Device Errata

Skywire® Raspberry Pi Adapter

NimbeLink Corp

Updated: July 2017

2. Applications Affected

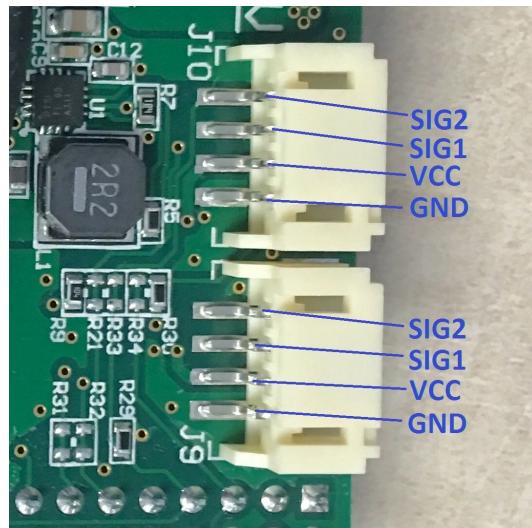
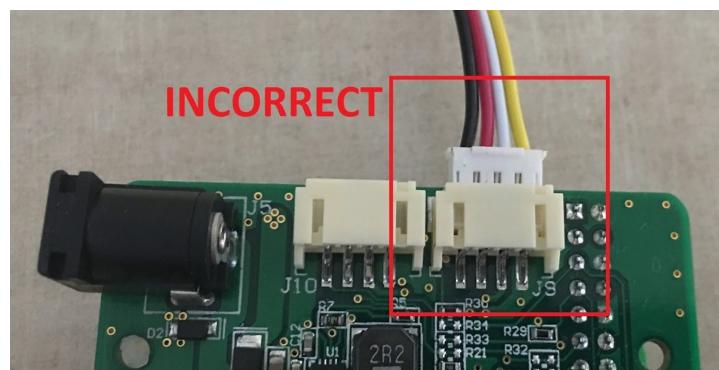
Applications using the Grove connectors on NL-AB-RPI adapter board with PCB revision 1001430 REV A are affected. The grove connector pins are reversed, as shown in the image below. Users who wish to use Grove sensors on affected PCBs must follow the steps outlined in section four of this errata.

Grove sensors using unmodified cables should not be directly attached to the Grove connectors on affected boards as this may cause shorts and/or damage to the sensor or Raspberry Pi.

3. How to Identify Affected Product

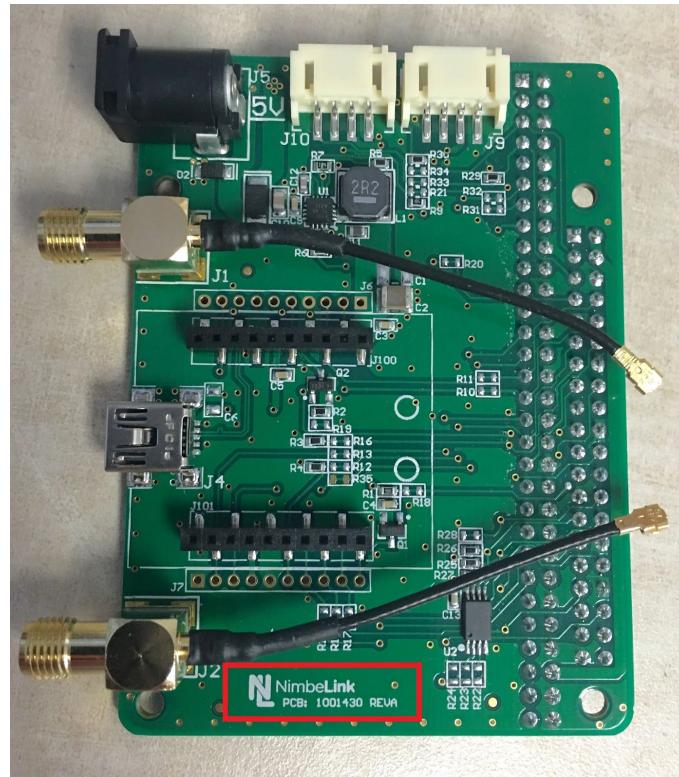
The PCB revision number is located on the bottom of the top side of the PCB. This Errata affects all NL-AB-RPI boards with a PCB revision number of 1001430 Rev A.

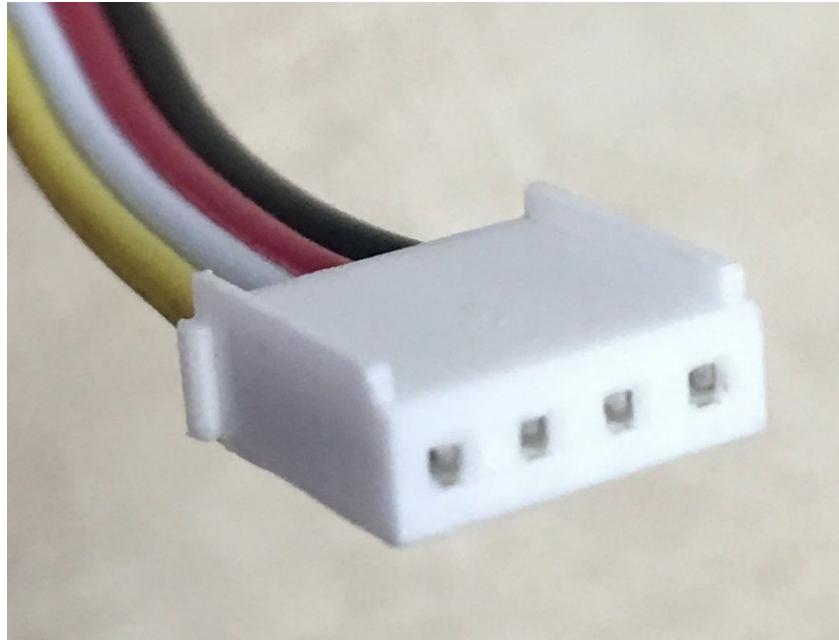
The suggested workaround is to modify the Grove sensor cable connector to allow it to be plugged into the adapter upside down. Users will need to remove the polarity tabs from the Grove connector on the cable. To remove the tabs follow these steps:

1. Identify the side of the cable that will be modified.
